The T118		lerance is	GB / T180	4-m; the sl	nape tolerar	nce is GB /	desi gn	Wang Enda	2024/3/29	Jie Xinhua Technology				mat erial	ADC12
A1.3	⊠	1. Modify the size of 2 places;	2024.3.13	basic ruler, pole	>6~30		> 120~400	> 400~100 0	> 1000~20 00	> 2000~40 00	examin e and			Co.,	LTD		•	type	SV05P
A1.2	Δ	1, increase the inverted corner R1,4;	2024.1.30	of inch section, limit	±0.2	±0.3	±0.5	±0.8	±1.2	±2	verify			6.	I				11/41/01/05/01/01/01

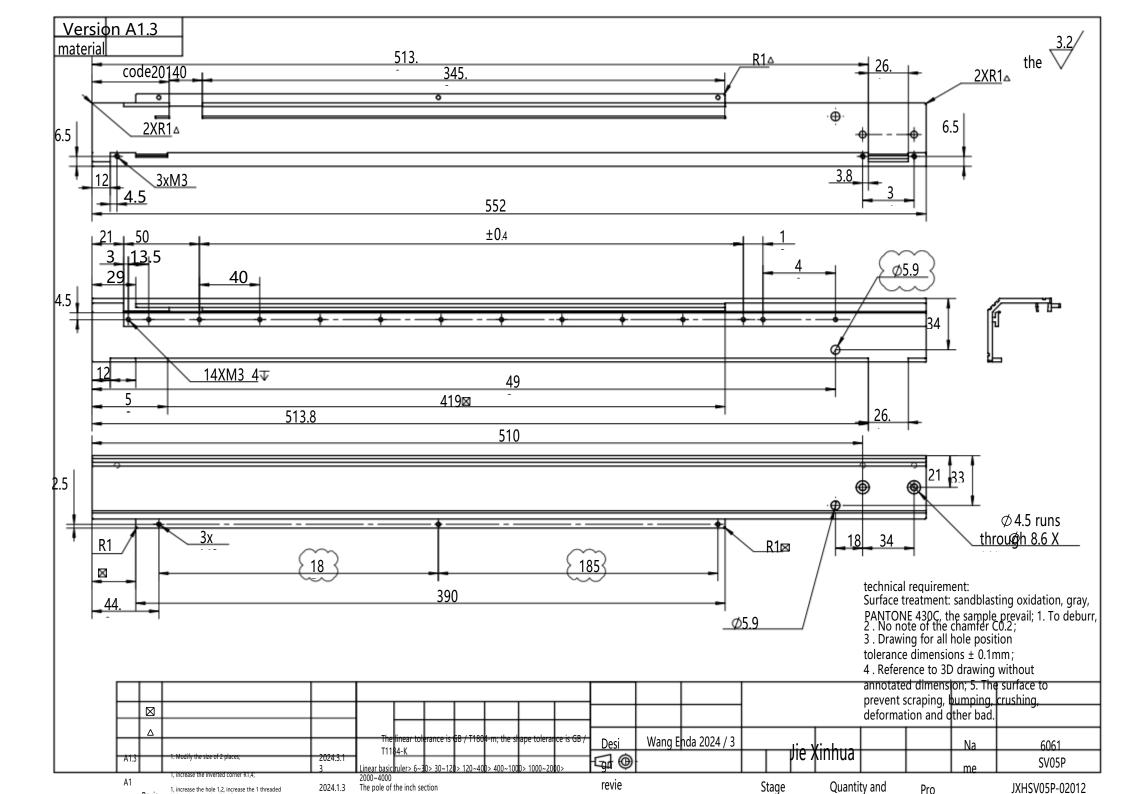
ĺ					deviation value										n	narking	g	ntity		numbe	
	A1.1	revisio n bars	1, increase the hole 1,2, increase the 1 threaded hole; 3, increase the chamfer 2; 4, change the hole distance of 185, a total of 2;		Straight degree peace The surface	≤10	> 10~30	> 30~100	> 100~300	> 300~100 0	> 1000~30 00	(1, the 1	1				1	2:1	nam	Z-axis profile 2
	edi tio n	tab	Change the content	date	degree is not noted Tolerance value	0.05	0.1	0.2	0.4	0.6	0.8									е
